Southern Services Ltd (Extension)

19 March 2023

Shed 03: The structure is single storied steel shed.

Lack of lateral stability in long direction

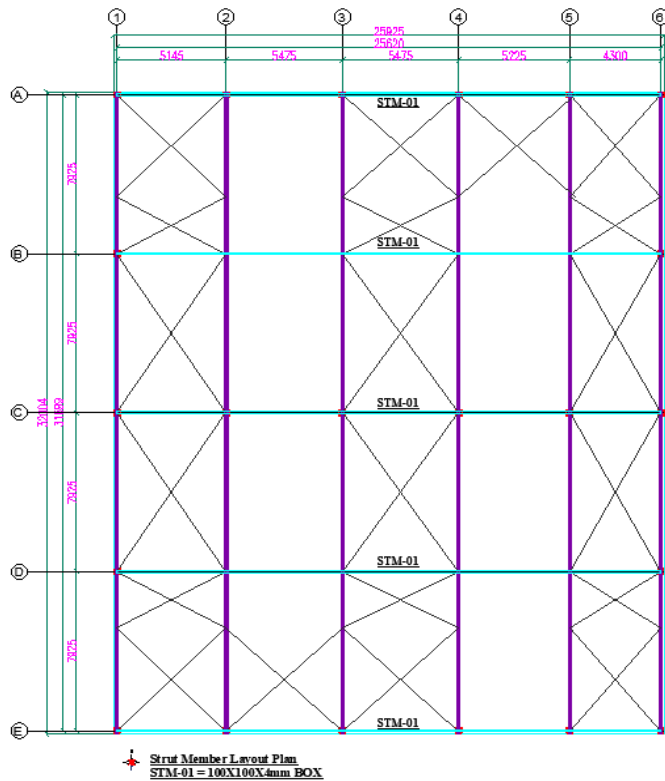
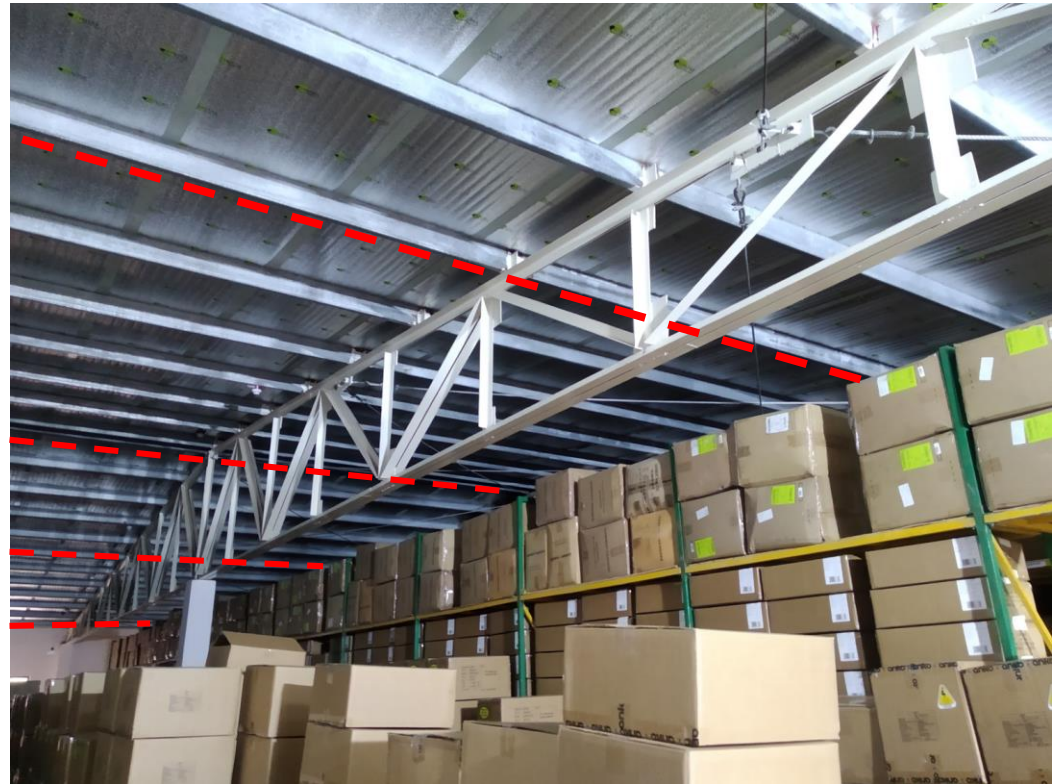
Continuous compression member
shown in the as-built drawing

Absence of continuous compression member at the shed

The building engineer is required to review the lateral stability of the shed.

Inconsistences in as-built drawing

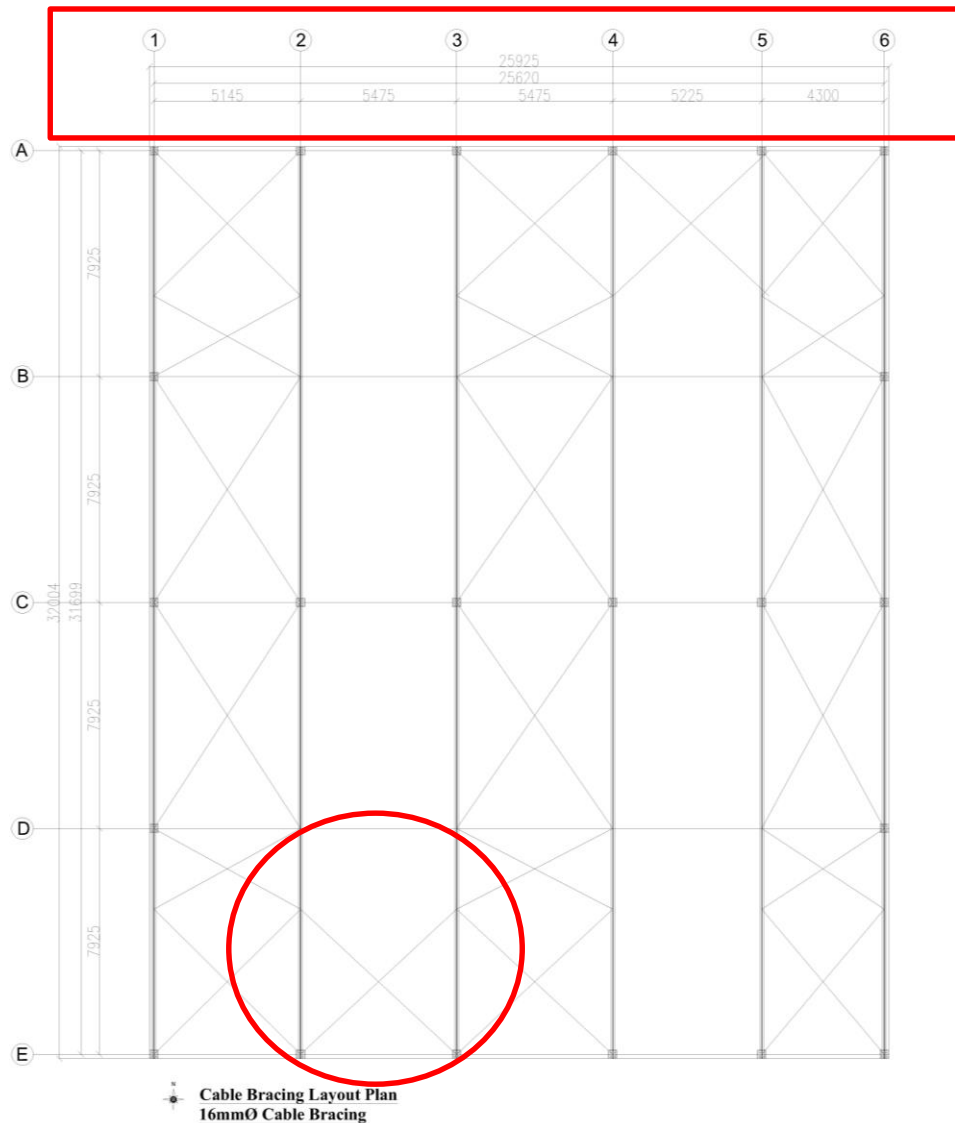
Grid dimension not
matched with the drawing

16 mm cable bracing shown in drawing but on site
12 mm bracing found

Trolly impact on columns

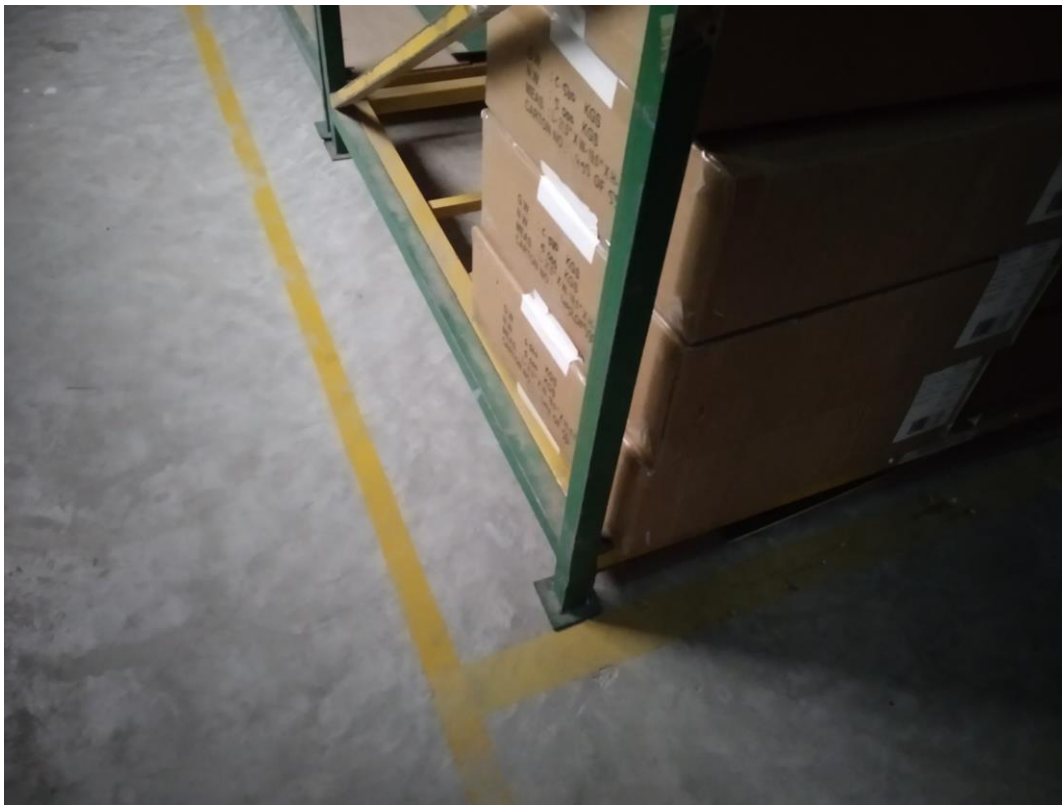
Column damaged by the trolley movement

Trolley impact was observed in the columns. Building engineer is required to repair the damaged columns and provided safety barrier surrounding the columns.
